17/02/2016 Ref: BFC-AFP113 Your ref: ENO20016

Title
 WESTERN POWER DISTRIBUTION
 (BRECHFA FOREST CONNECTION) ORDER
 LAND PLANS
 (REGULATION 5(2)(i)(ii))
 SECTION C

ORIGINATOR/DRAWING NO	APPLICATION NO	GIS
03_13571_71	EN020016	A1
PROJECT/DRAWING NO	LEVEL/CLASSIFICATION	SCALE
15/WPD/014	C/LP/PS/6	1:2,500
SHEET 6 OF 10	NA	DATE
		B

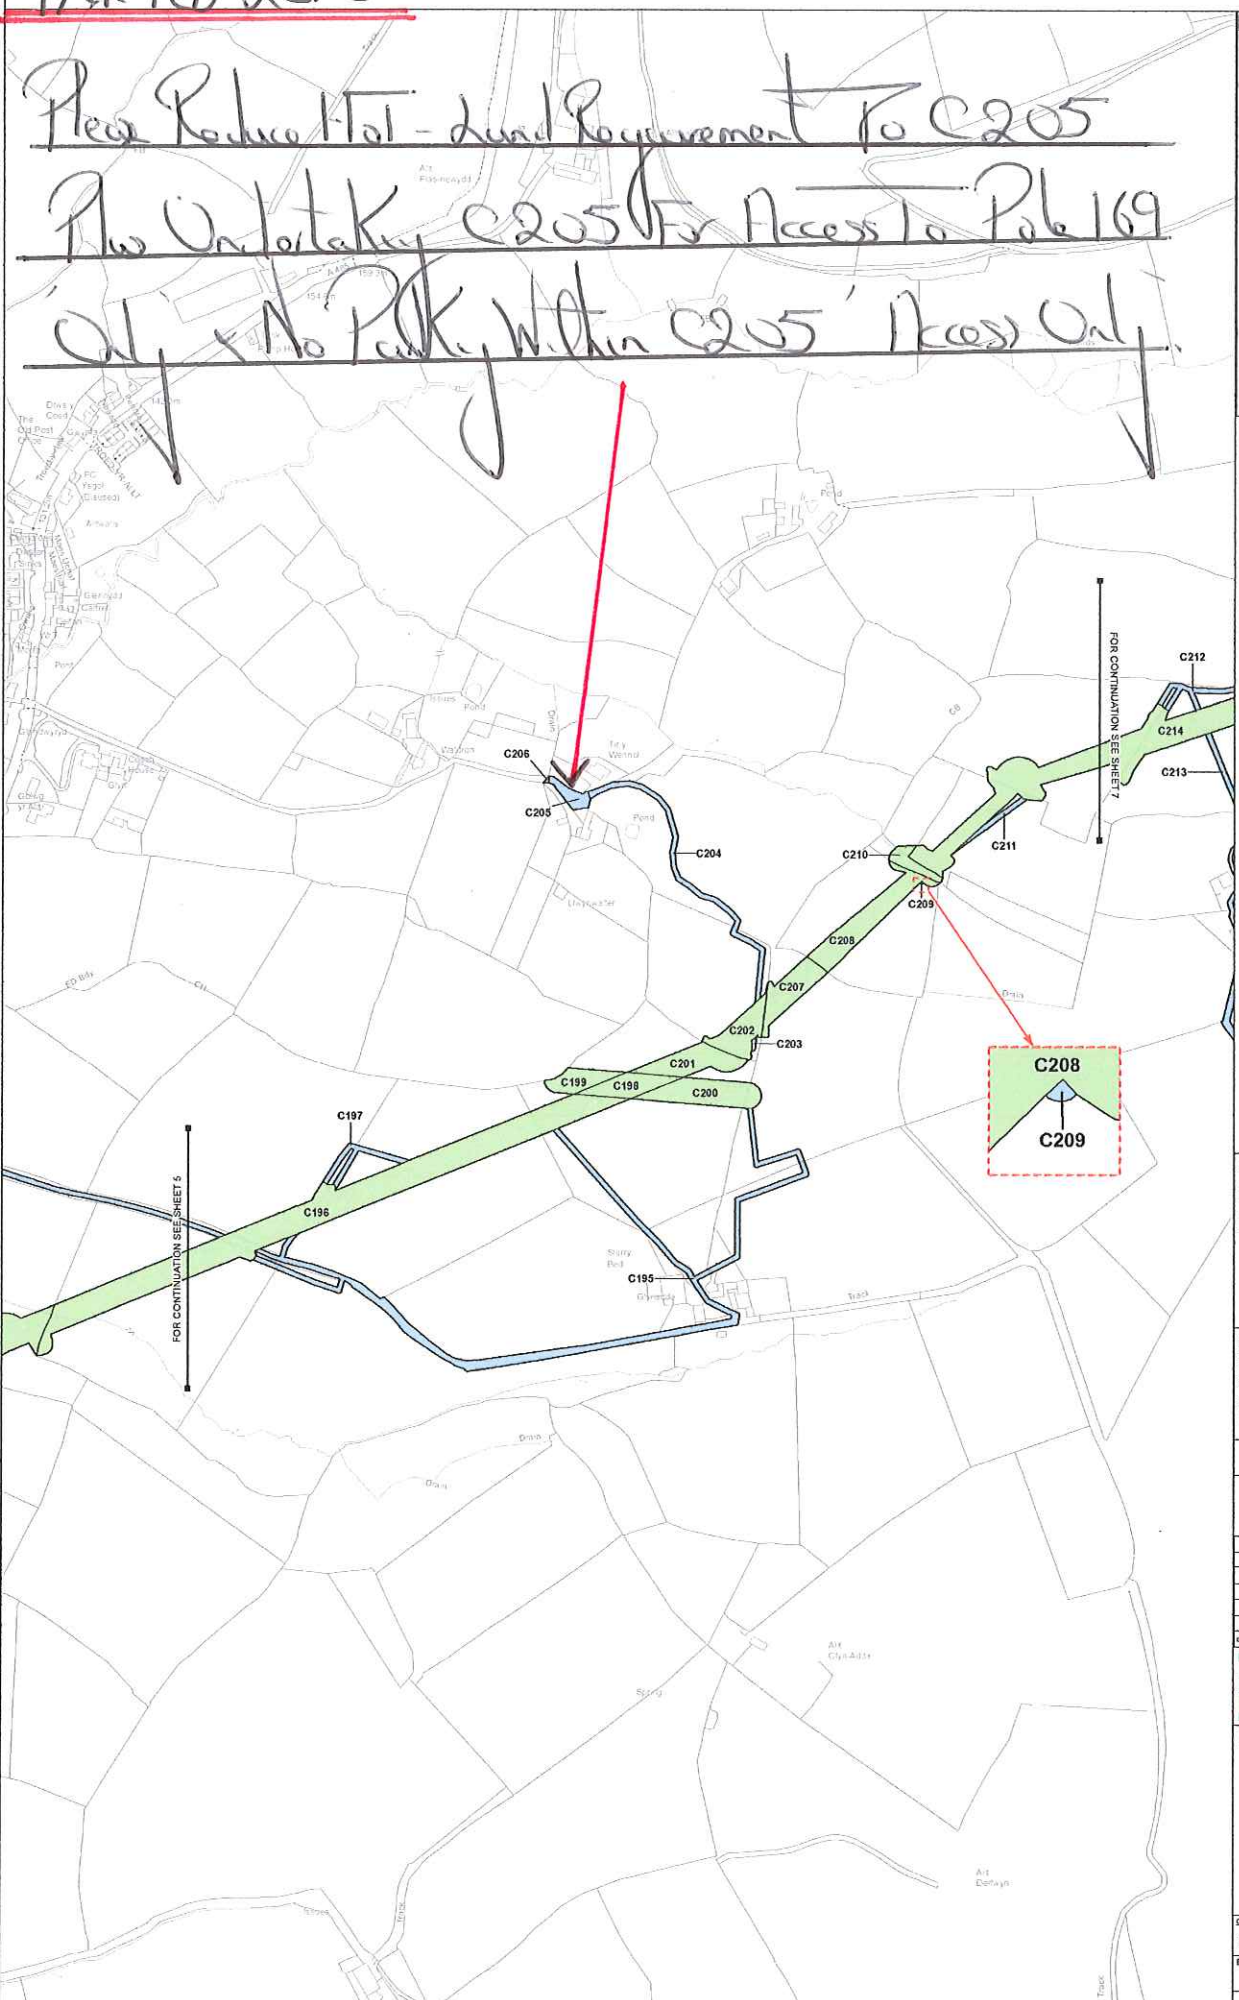
Prop Reduce Ht - Land Requirement To C205
 Prop On Lot 4, C205 For Access To Pub 169
 Only No Poles Within C205' Area Only

Scale = 1:2,000 @ A3

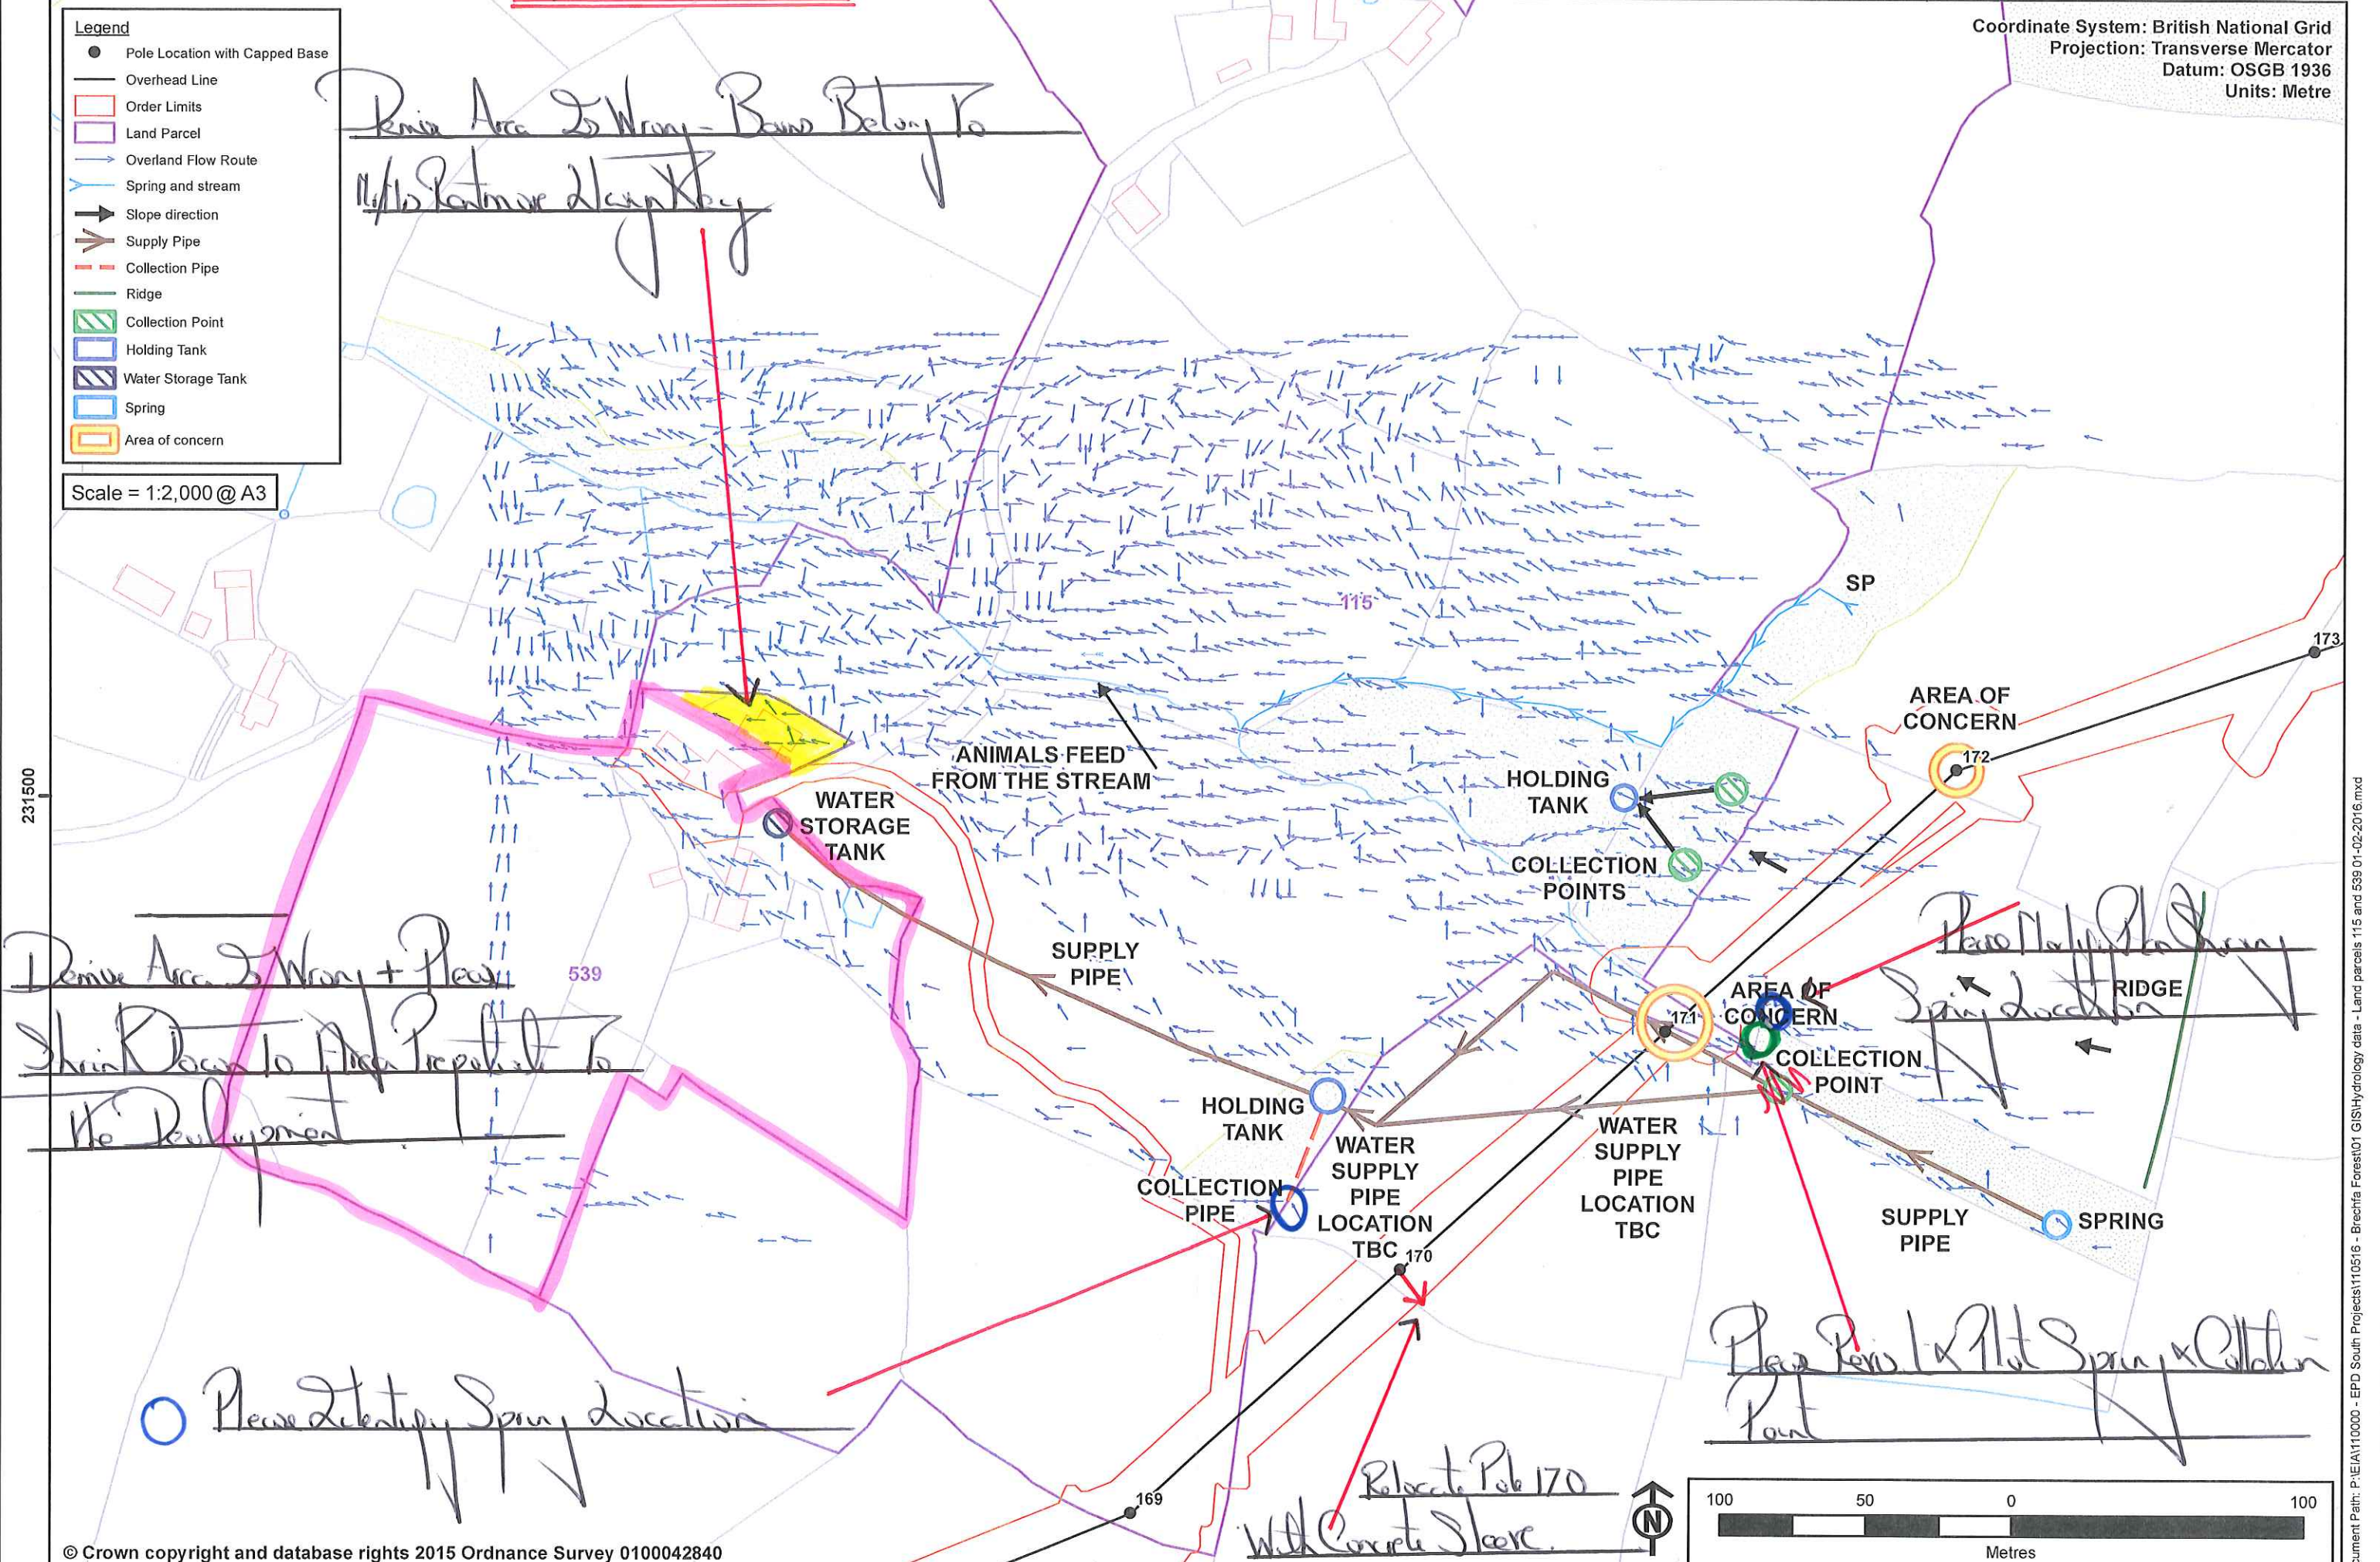
- The map of our water supply sent to me by Mr Buxton (enclosed) still includes part of Mr and Mrs Rentmore's property. I would like this taken off ASAP as I instructed Mr Buxton when he visited here to see the water supply the correct land boundary between us and our neighbour. I also said the same thing at stage 3 consultation and I was told the map would be changed to reflect the correct land boundary. Mr Jones has marked out the correct boundary to my property. I trust WPD will now effect the changes. The corrugated iron barns belong to a third party – **THEY DO NOT BELONG TO ME.**
- The map does not show my springs (except the one that we did not look at as it is only in use in the summer and is not affected by the scheme). These have now been drawn in by us

today - and I want the map to be accurate otherwise mistakes will be made. There is no 'area of concern' around pole 170. **Please amend the plan.**

- There is no indication that it was agreed on site that pole 171 would be moved 5 metres downhill away from the spring. **Please amend the plan.**
- There is no indication that it was also agreed that pole 170 would be moved 5 metres uphill away from the other spring. **Please amend the plan.**
- I would like this agreement to be recorded so that the poles are not sited incorrectly.

Remove Area 2 Wrong + Please
Shrink Down to Area Reported to
No Development

○ Please identify Spring location

Relocate Pole 170
With Concrete Slab

Please identify Spring location
RIDGE

Please Refer to Plot Spring & Catchment Point
